# Proposal how to structure the RESS safety requirements

12-14 April 2011

RESS-4-14

- Red = RESS-3-7 Vibration Draft JP Proposal  
+ Further comment (in dotted box) / proposal (with yellow marker)
- Green = Remarks or amendments by the secretary
- Purple = Remarks from TÜV and BMW under § 3.7
- Blue = Remarks from France

Diagram 1 – minimum shock pulse

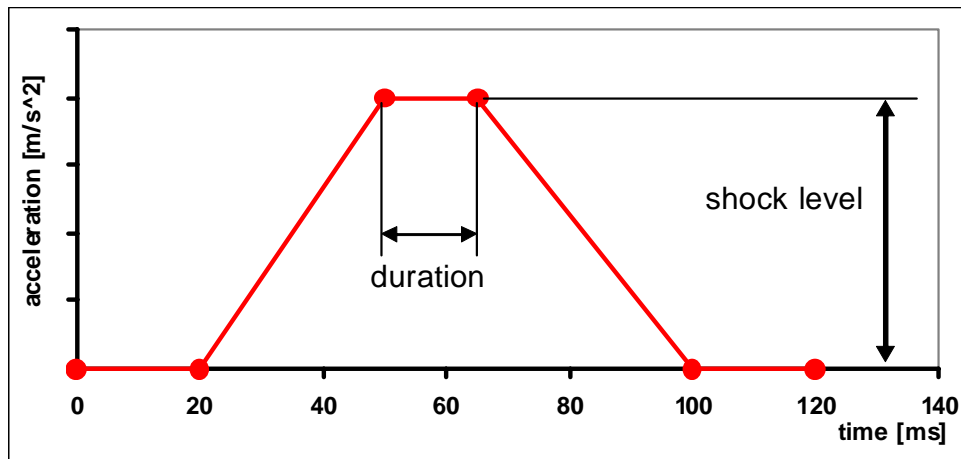
## Remark:

Frontal impact: the R 17 corridor should be incorporated in the diagram 1 (upper limit). As it is said in the test protocol § 3.4 in RESS 3-3, the test undergoes by the device can be performed via the R94 on the vehicle. So at least, the device pulse has to be equivalent to the vehicle pulse. The R17 corridor is a frontal impact R12 simulation in order to validate seat entities. The same philosophy is applied for example to the CRS in R44 with a stronger requirement (fixed rise time).

So, we think the half sinus proposed does not totally cover the need and we think the R17 corridor is more representative and relevant solution for this RESS test. Therefore, a half sinus included in the R17 corridor would be also acceptable.

Lateral impact: We propose to use the same pulse taken from R 17 with a lower test levels and a lower duration. At this time, we need more time to define exactly the signals characteristics.

Diagram 2 – sinus shock pulse

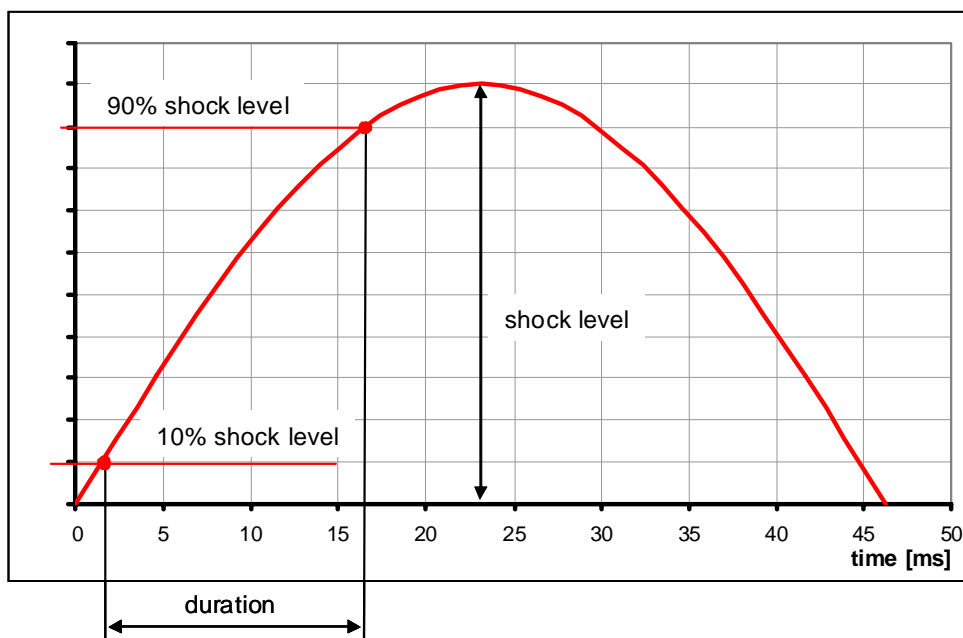
<JASIC Comment>

Pulse a) and b) are not considered as equivalent and pulse b) will be difficult to achieve at lower shock level.

Figure 7:

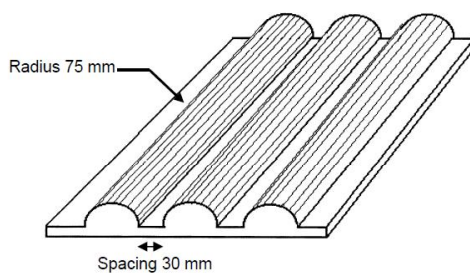
Crush a [RESS or pack(s)] between a resistance and a crush plate described in figure 7 with a force of [100 kN] in [X seconds; how fast] during [Y seconds; how long] => **action item for German working group**

~~To better precise the crush plate position with a drawing.~~
